HYDRO COMMENTS

INTRODUCTION

The following comments focus on the effects of the FCRPS on listed salmon stocks within the Columbia River Basin. The comments are set forth in three sections. The first addresses general criticisms with NMFS analytical approach. The second section addresses our concerns with the “Full Mitigation” concept in NMFS jeopardy standard and analysis. The third is a section by section review of chapter nine in the FCRPS BiOp.

Figure 1. This figure depicts optimistic input values selected by NMFS for its jeopardy analysis and other more realistic values not considered by NMFS.

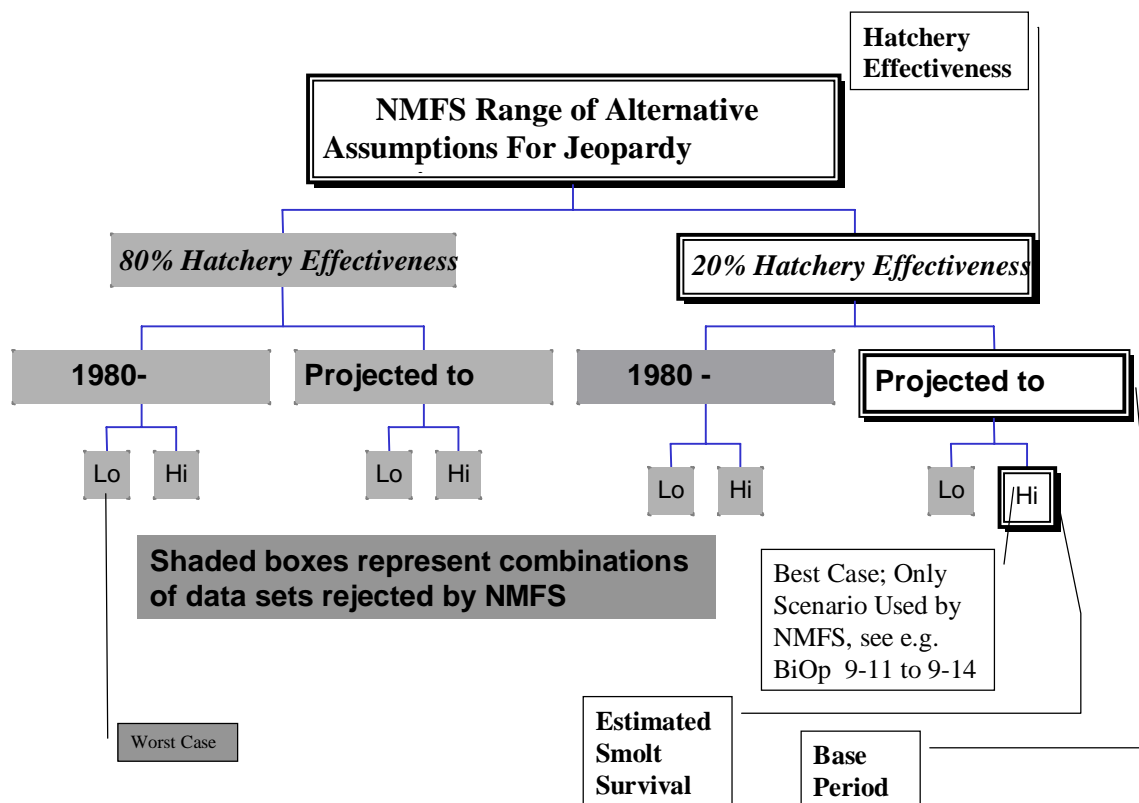
We are also concerned about NMFS selective use of input values for the analytical framework. See figure 1. A modified Dennis (1991) model is used to estimate Lambda, the population growth rate (lambdas greater than one denote a growing population; less than one a decreasing population). Although lambdas in the past were calculated using recruit per spawner data, where recruits are linked to the number of spawners that generated them roughly four and five years previously, the current methodology link recruits to the number of spawners the year before. This approach, first, makes no sense from the biological perspective and, second, produces substantial overestimates Lambda.

The time series of years chosen to estimate Lambda also yield high values of Lambda. Previously NMFS has hypothesized that 1980 represents the beginning of a new era for the hydrosystem, a point where the debris problems had been remedied. If so, the 1978 brood year would have been the first brood to have benefited from the new era, beginning in 1980. But NMFS began their analysis with the 1980 brood year, a choice that lacks a rationale and further raises the values of Lambda for the Snake River stocks. There is additional concern that the rate of decline is increasing (referred to as non-stationarity; Oosterhout 2000). This is a concern because the resulting lambda may mask an increasingly threatening situation that could, in fact, be evidence of a steepening decline known as an extinction vortex. Additionally, the assumed population increases through 2004 are dubious.

Subyearling chinook survival from sites above pool to Lower Granite Dam tailrace,
1999 and 2000

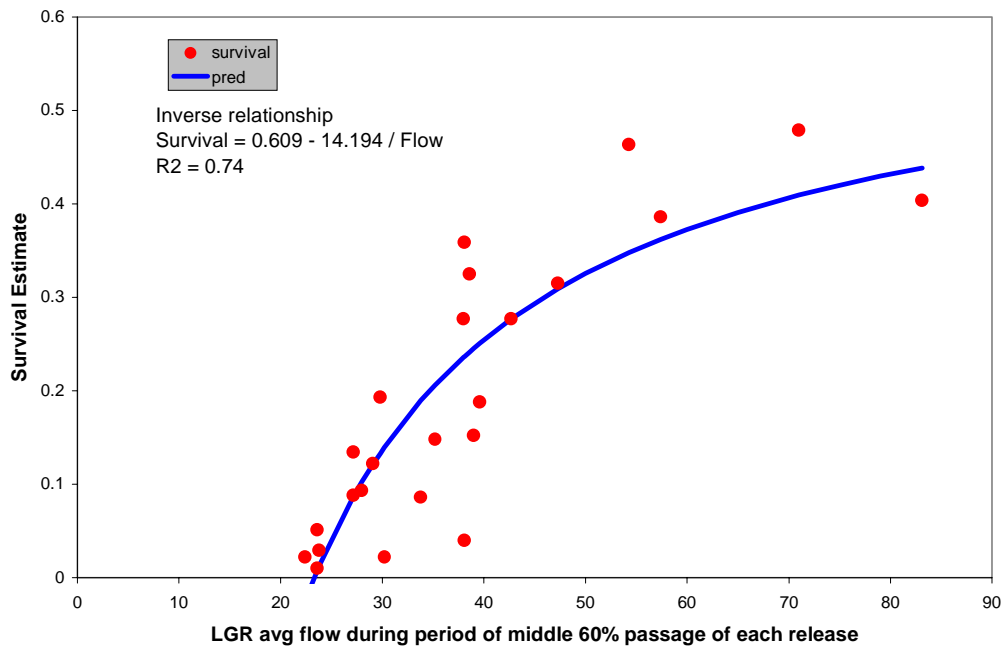
The following tables and attached graph, developed by the Fish Passage Center, illustrate a significant flow/survival relationship for these groups of summer migrants. Subyearling fall chinook PIT tagged at Lyons Ferry Hatchery and trucked and released at various sites in the Snake River from early June through early July show substantially lower survival estimates to Lower Granite Dam when average flows during the period of middle 60% passage at Lower Granite Dam drops below 50 kcfs. Flows in 2000 during the summer were lower than in 1999, and estimated survival to Lower Granite Dam remained lower for each weekly release group. The results here reflect the year-to-year difference for those fall chinook that outmigrated as subyearlings.

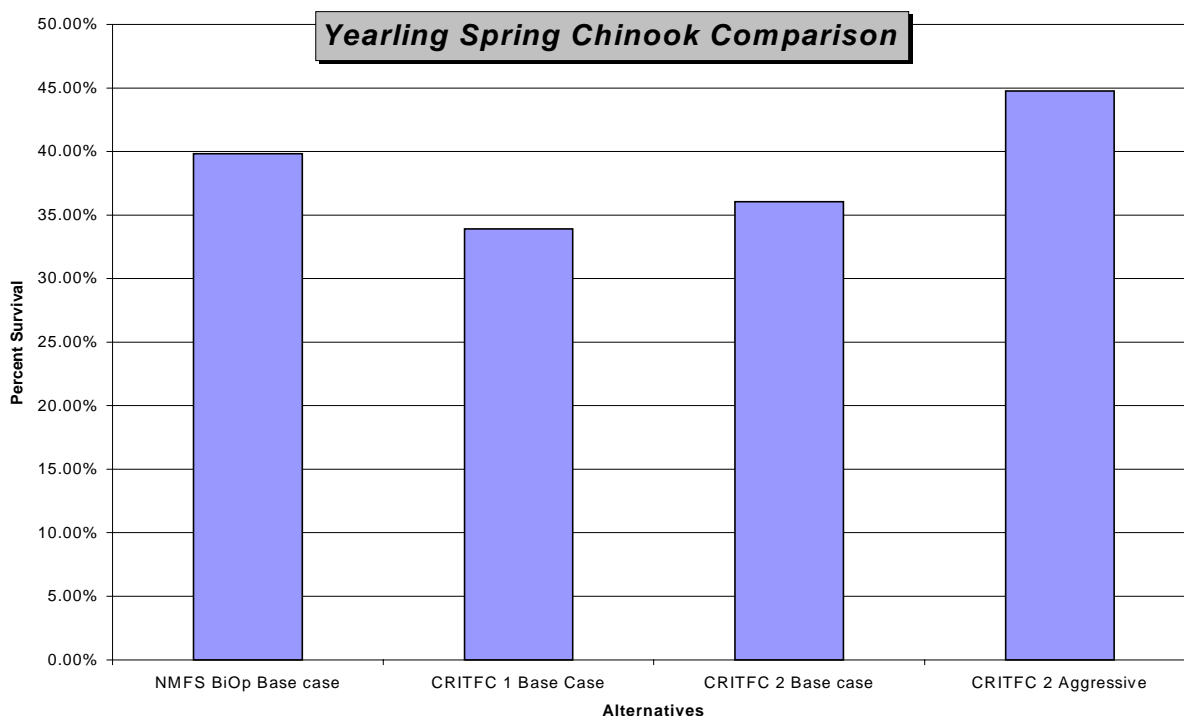
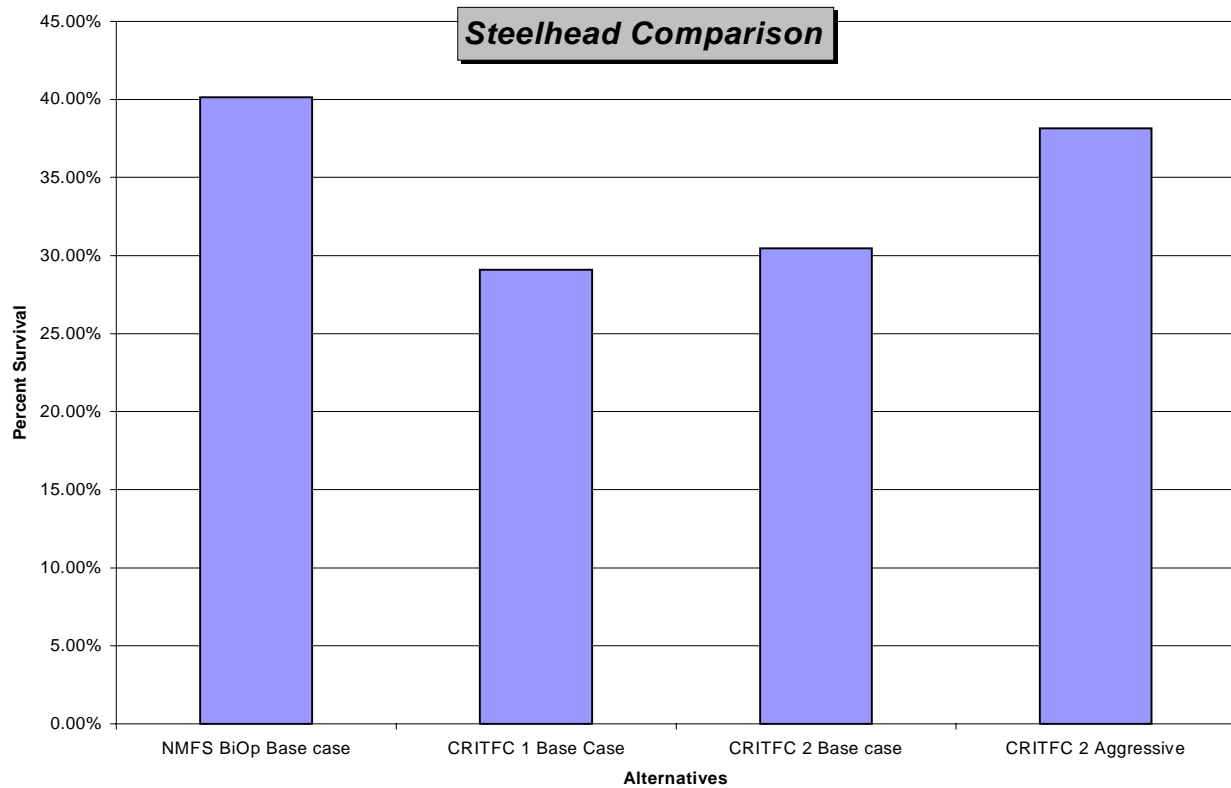
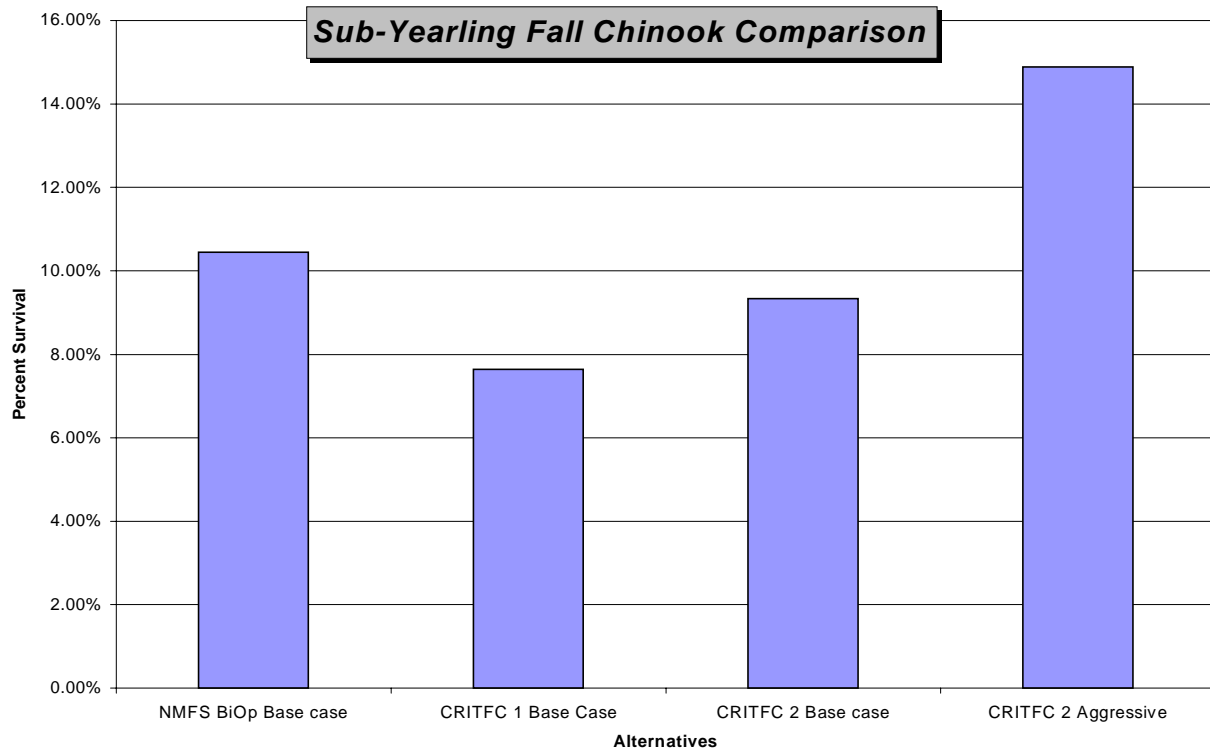
After inserting more conservative and reasonable assumptions, using available scientific analyses and feasibility, it appears that the NMFS Base Case and Aggressive Program both substantially overestimated survival estimates at each project and through the FCRPS migration corridor. If the CRITFC model parameters and resulting survival estimates are considered, it is apparent that 1) reach and project survival as modeled by NMFS is far less than NMFS' current estimates and 2) the hydrosystem will have to make significantly more improvements to achieve its objectives. This will mean that more aggressive measures, such as draw downs and breaching will be needed to meet FCRPS performance standards and population growth rates. Again, it must be stressed that the SIMPAS model fails to incorporate the flow-survival relationship, a life cycle, spawner to spawner approach, which accounts for among other things, the effect of delayed mortality.

While the CRITFC Alternative 2 results do not show the magnitude of survival improvement that NMFS model runs achieved with their speculative assumptions and biases, the CRITFC Alternative 2 results do show a marked survival improvement under both conditions. SIMPAS model simulations indicate that if the *CRITFC 2000 River Operations Plan* was adopted under current conditions, a measurable survival improvement is apparent, with the possible exception of fall chinook. This is likely because the SIMPAS model assumes great benefits for juvenile transportation because delayed mortality is not accounted for in the model. A greater survival benefit is realized when additional improvements are included as model parameters, such as full flow surface bypass. Model restrictions prevent a true assessment of the CRITFC Alternative 2 Aggressive simulation, because the model cannot accommodate benefits, such as increased pool survival, related to improved flows and a normative hydrograph.
